Title: Stage 1&2 ROAD SAFETY AUDIT

St. Joseph's Housing Development, Ballinasloe, Co. Galway.

Client: Galway Co. Co.

Report reference: 1808R01

Drawing 22316/CE/001/PL Rev PL, Pedestrian crossing at St. Joseph's Place.

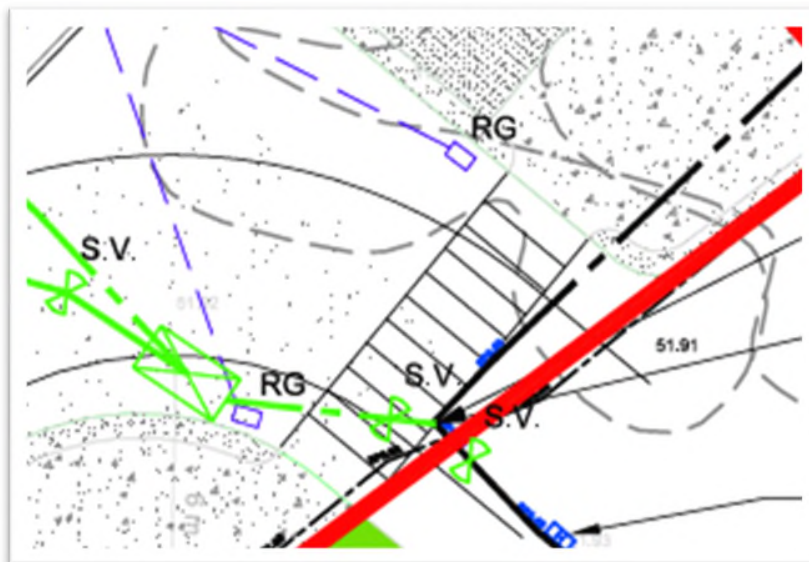
Zebra crossing type markings are shown on the drawings for the pedestrian crossing at St. Joseph's Place which links to the pedestrian link to the school. These markings, if installed, may give rise to confusion over priority. A pedestrian may think that they have priority akin to a zebra crossing but a driver may not assume so given the absence of beacons and other road markings. The confusion may lead to collisions with pedestrians.

It is recommended that at the detailed design stage that the striped road markings be omitted.

Drawing 22316/CE/001/PL Rev PL, Disabled parking bay.

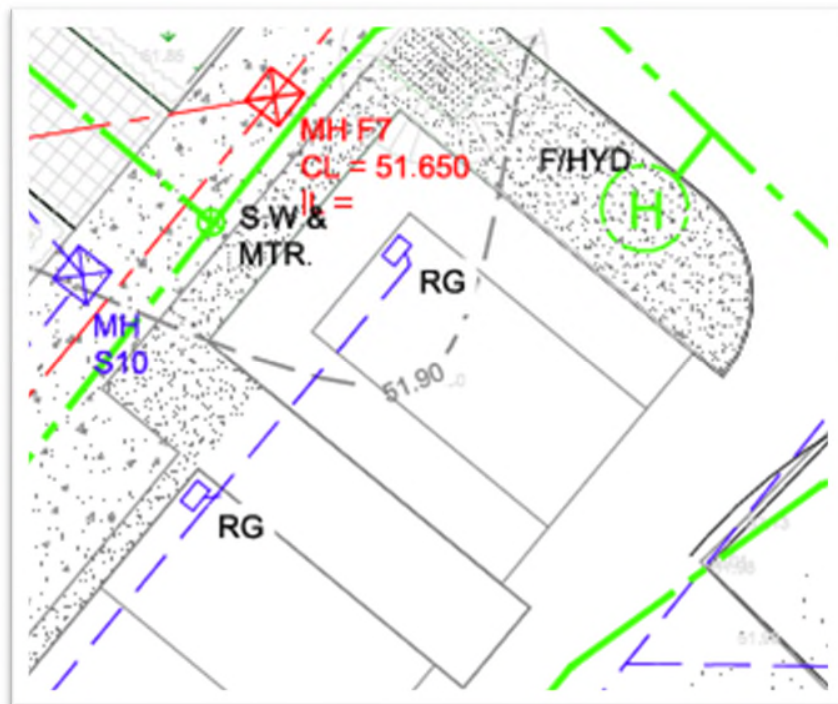
It is proposed to provide a disabled parking bay adjacent to house no. 1. It is unclear if a dropped kerb is proposed to allow access from the bay to the footpath network. A lack of a dropped kerb could lead to inaccessibility for some and possible trips and falls.

It is recommended that at detailed design stage that a dropped kerb be provided to allow access to the footpath network.

Drawing 22316/CE/001/PL Rev PL, Loop system for refuse vehicles.

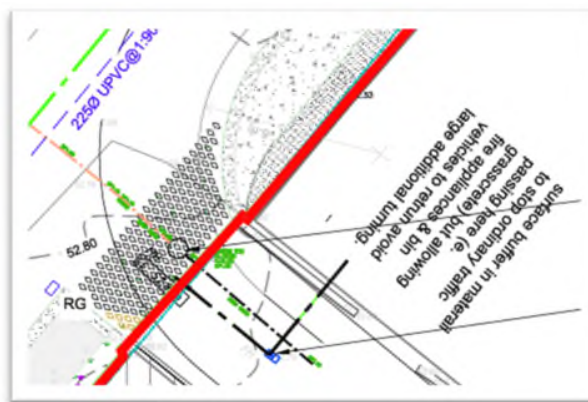
It is proposed to have a one-way loop system for refuse vehicles and emergency vehicles. Grasscrete or similar is proposed to distinguish the surface. Given that the lane is surfaced and it provides a more direct link to the R446 it will most likely form the pedestrian desire line. An unsuitable surface for pedestrians could lead to slips and falls

It is recommended therefore that whatever surface is chosen at the detailed design stage that it is suitable for pedestrians to use.

It is assumed that the one-way system will be self-regulated by residents who will prohibit general traffic from using the route. Some signage and road markings may be required if this is not been adhered to.
